APPLICATION NO.	FILING DATE	FIRST NAMED INVENTOR	ATTORNEY DOCKET NO.	CONFIRMATION NO.
10/671,842	09/25/2003	Michael D. Brookshire	121236.00003	9648
26707	7590	08/14/2006	EXAMINER	
QUARLES & BRADY LLP RENAISSANCE ONE TWO NORTH CENTRAL AVENUE PHOENIX, AZ 85004-2391			REESE, DAVID C	
			ART UNIT	PAPER NUMBER
			3677

Office Action Summary

DETAILED ACTION

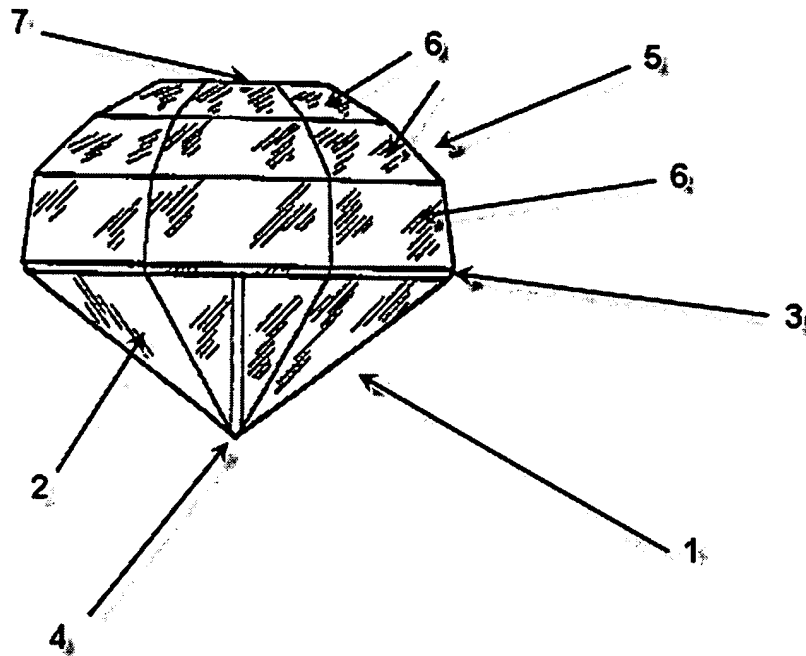
As for Claim 13, Stafford teaches of a diamond (see figure below), comprising:

a pavilion (1) extending from a girdle (3) to a culet (4), wherein the girdle (3) extends no further than a widest circumference of the crown (5) and the pavilion (1) extends no further than a widest circumference of the girdle (3); and

a crown (5) in the form of a symmetrical hemisphere having a first set of facets (first 6) disposed above the girdle (3) and a second set of facets (second 6) disposed between the first set (first 6) of facets and an apex (7) of the crown (5), wherein the first set of facets (first 6) is cut at a first angle with respect to a reference line which is tangential to the apex (7) of the crown (5) and the second set of facets (second 6) is cut at a second angle with respect to the reference line which is less than the first angle, each of the sets of facets (first and second 6) having an equal number of facets (6).

The difference between the claim and Stafford is that Stafford does not expressly disclose that the crown (5) has at least ten sets of facets between the girdle (3) and the apex (7) of the crown (5). It would have been an obvious matter of design choice to modify Stafford (adding additional sets of facets between the girdle and apex of the crown so as to go from 3 sets to at least 10 sets of facets), since applicant has not disclosed that such a particular orientation creates any unexpected result. It appears that the invention would perform equally well as the invention disclosed by Stafford. It is extremely old, well known, readily apparent and profoundly obvious to change the size, shape, number, orientation, angles, percentages, and create ranges for facets and the gemstone in its entirety as to merely alter the aesthetics of said gemstone for the corresponding and resulting properties including brilliance, radiance, etc. for the utility of mere user preference. It is also extremely well known that altering said features will produce different properties radiating from said gemstone, depending on the changes and alterations made.

As for Claim 23, Stafford teaches of a diamond (see figure above), comprising:
a pavilion (1) having a plurality of facets (2) disposed from a girdle (3) to a culet (4); and
a dome-shaped crown (5) disposed above the girdle (3), wherein the girdle (3) extends no further than a widest circumference of the dome-shaped crown (5) and the pavilion (1) extends no further than a widest circumference of the girdle (3), the dome-shaped crown (5) formed from a at least ten sets (in view of that discussed from Claim 13 above) of facets (6) cut with monotonically decreasing angle to form a curved contour in accordance with a dome shape from the girdle (3) to an apex (7) of the dome-shaped crown (5).
